NUMBER
21-01-033HG
MODEL(S)
G80 (DH)
, ,

Technical Service Bulletin

G80 (DH) MULTI FUSE REPLACEMENT KIT INSTALLATION (RECALL CAMPAIGN 006G)

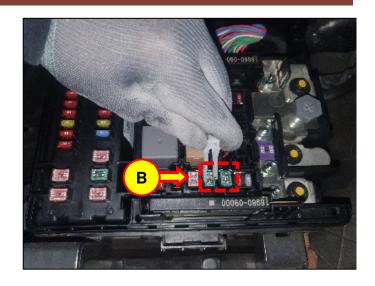
4. Remove the ESC/VDC1, ESC/VDC2 40A fuses (B).

- 5. Install the supplied fuses (C).
 - ESC/VDC1 → 20A
 - ESC/VDC2 → 25A

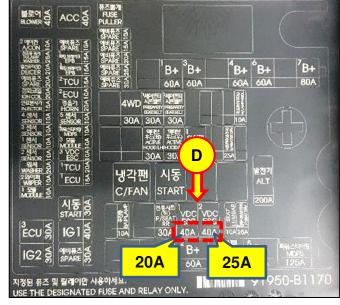
6. Attach the supplied sticker labels (D) to the upper fuse cover in these positions:

ESC/VDC1: 20AESC/VDC2: 25A
